PROPOSED NEW HOUSE W/ JR. ADU AND DETACHED ADU
FOR: JOSE & DOLORES CASTILLO
110 CHESTNUT ST SALINAS CA 93901
A.P.N. 002-453-005-000

UTILITY PLAN
GRADING & DRAINING
THRESHOLD DETERMINATION

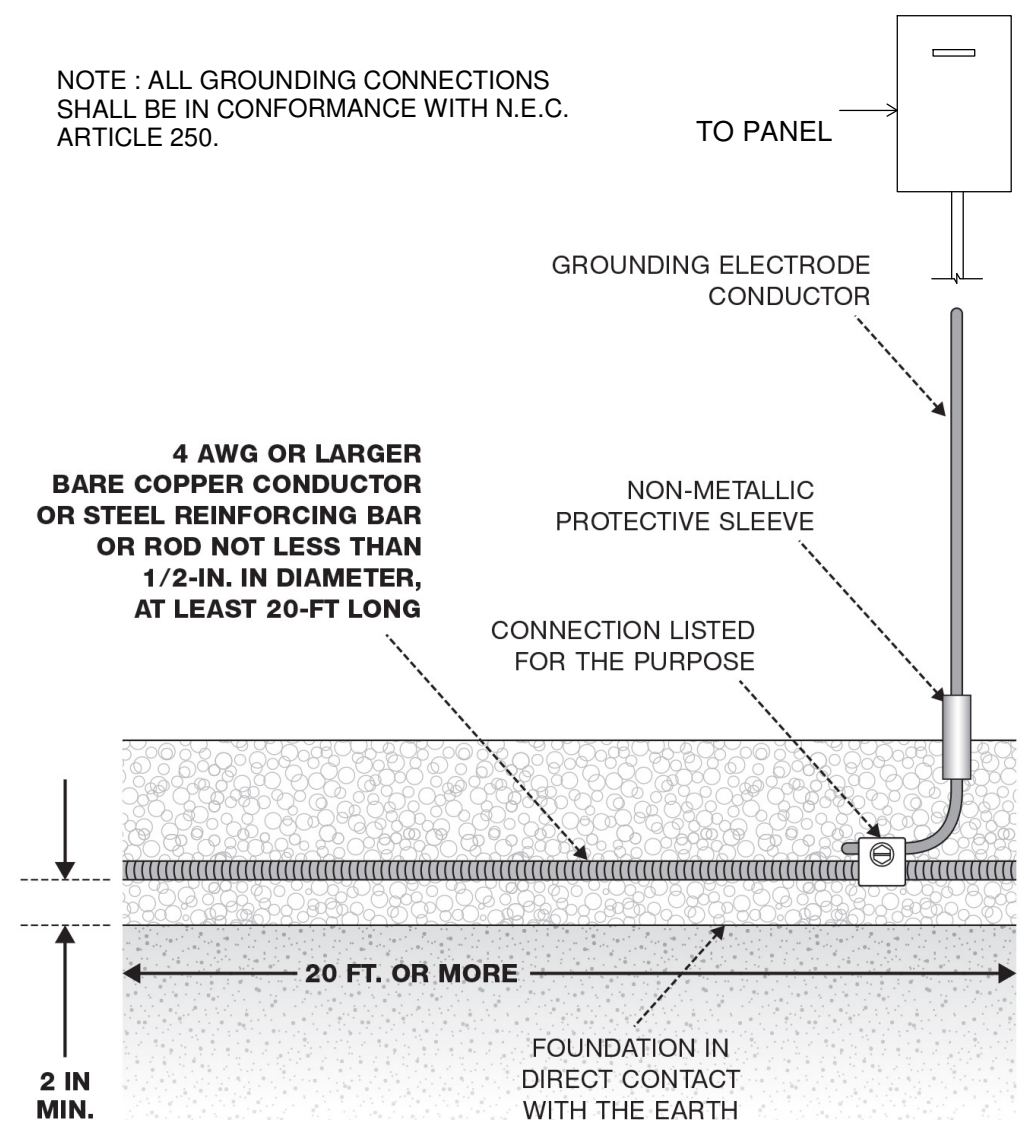
COMMENT #2. GRADING AND DRAINAGE PLAN
(ADD THE FOLLOWING NOTE TO THE SET OF PLANS)
(ALSO ADD ARROWS TO THE SITE PLAN TERRAIN, POINTING FROM REAR OF PROPERTY TO FRONT OF PROPERTY, SEE SITE PLAN REDLINES)

NOTE:
SURFACE SHALL SLOPE A MINIMUM OF 2% CRC SECTION R401.3 (EX.) AT LEAST 5'-0" MIN. FROM FOUNDATION WALLS TO LANDSCAPE. LOTS SHALL BE GRADED TO DRAIN SURFACE WATER AWAY FROM FOUNDATION WALLS. UNDERGROUND DRAINAGE SHALL BE PROVIDED, AS REQUIRED.

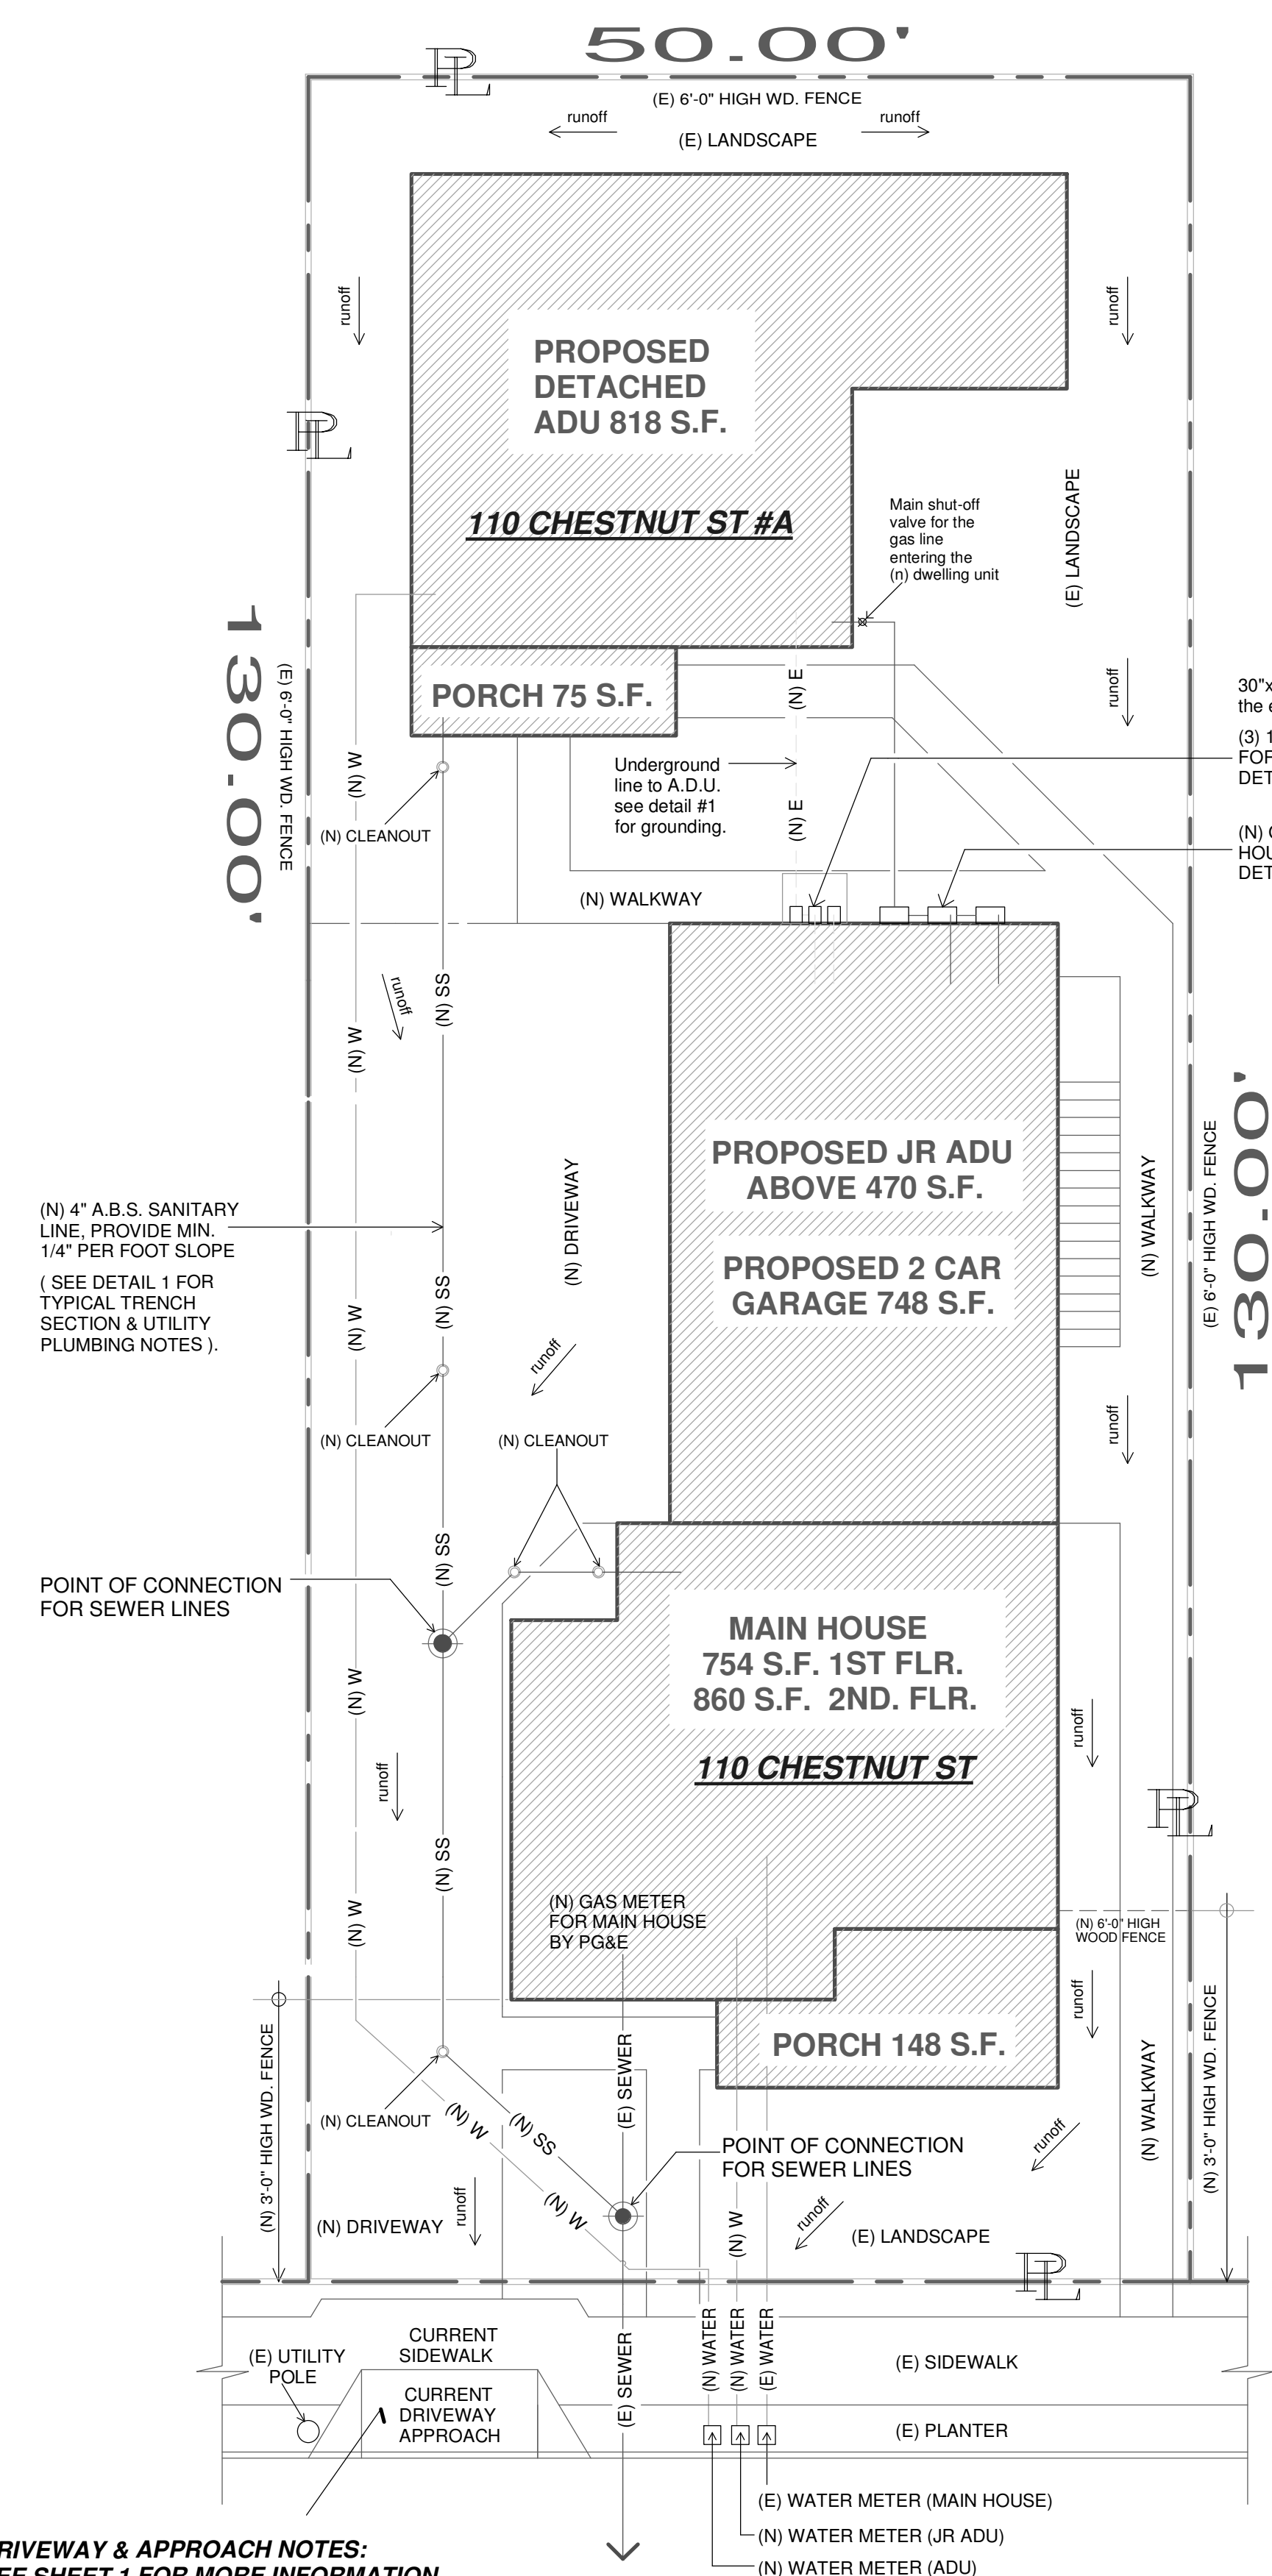
COMMENT #1. THRESHOLD DETERMINATION WORKSHEET
(SEE SUPPLEMENTAL DOCUMENT, AND EITHER SUBMIT SEPARATELY OR ADD TO SHEET)
